**Town of Kittery
Planning Board Meeting
May 11, 2023**

ITEM 1 – 6 Goodwin Road– Shoreland Development Plan Review

Kittery Planning Board
Findings of Fact
For 6 Goodwin Road
Shoreland Development Plan Review

SHORELAND DEVELOPMENT PLAN
OF LAND LOCATED AT
6 GOODWIN ROAD
KITTERY POINT, YORK COUNTY, MAINE
RECORD OWNER:
JOHN T. & LAUREL S. GOURVILLE
33 REYNOLDS ROAD
WAKEFIELD, MA 01880-3824

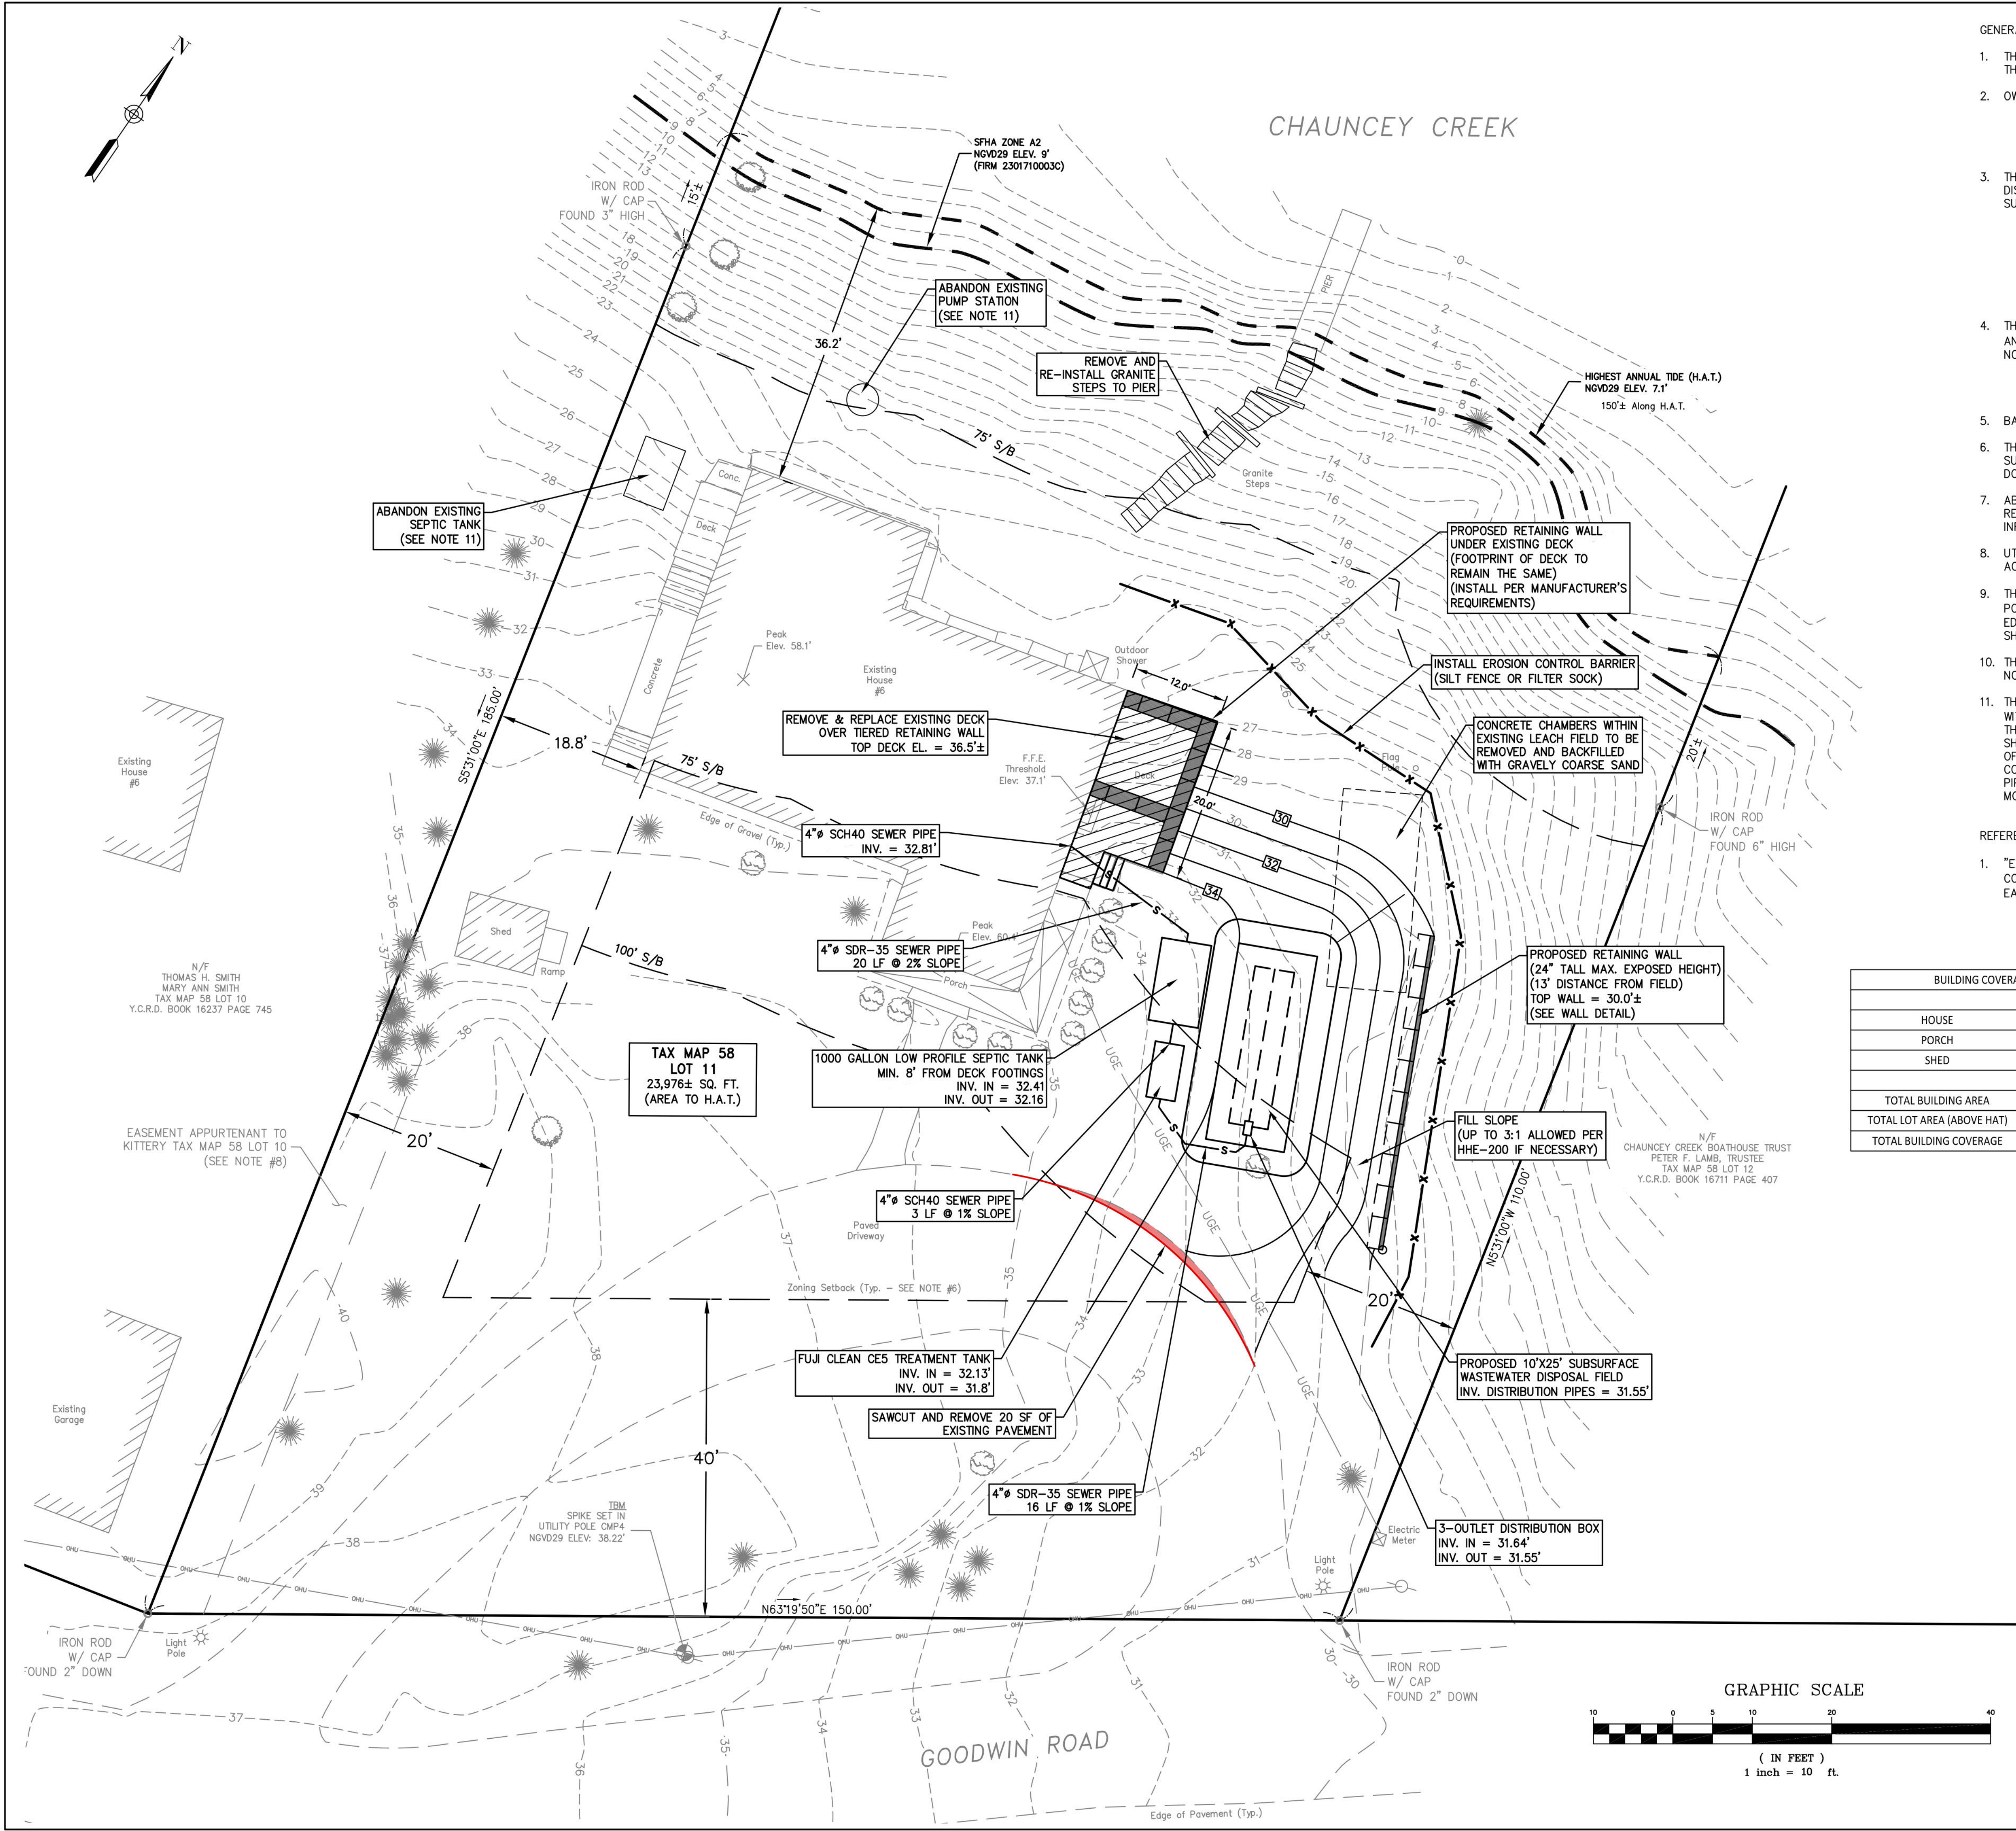
1. The current septic and pump systems will be at minimum drained of all contents, the tops removed, and the remaining portion of the tanks backfilled with granular backfill. All pipes will be plugged with mortar, all electrical and mechanical components of the pump station shall be removed before backfilling. A temporary erosion control barrier will be placed around the installation site for the duration of the project.

2. The Shoreland Overlay Zone Ordinance §16.4.28E(3)a requires new principal and accessory structures to be set back at least 100 feet, horizontal distance, from the normal high-water line of any water bodies, tributary streams, the upland edge of a coastal wetland, or the upland edge of a freshwater wetlands. As stated above, alteration of the deck is necessary to allow installation of plumbing to the new septic system. The deck will not be rebuilt closer to the waterbody and will retain the same dimensions as before.

3. §16.4.28.E(2) allows 20% of total lot area in the shoreland zoning overlay to be comprised of non-vegetated surfaces or structures. With a lot size of 23,976 sq ft, current devegetation sits at 6,037, or 25.2%. The property is a legally non-conforming lot, and the proposed plan will not increase the percentage of devegetated area on the property. The only increase in devegetated area comes from building the leach field retaining wall, which the plan compensates for by removing and re-vegetating 20 sq ft. of the existing driveway.
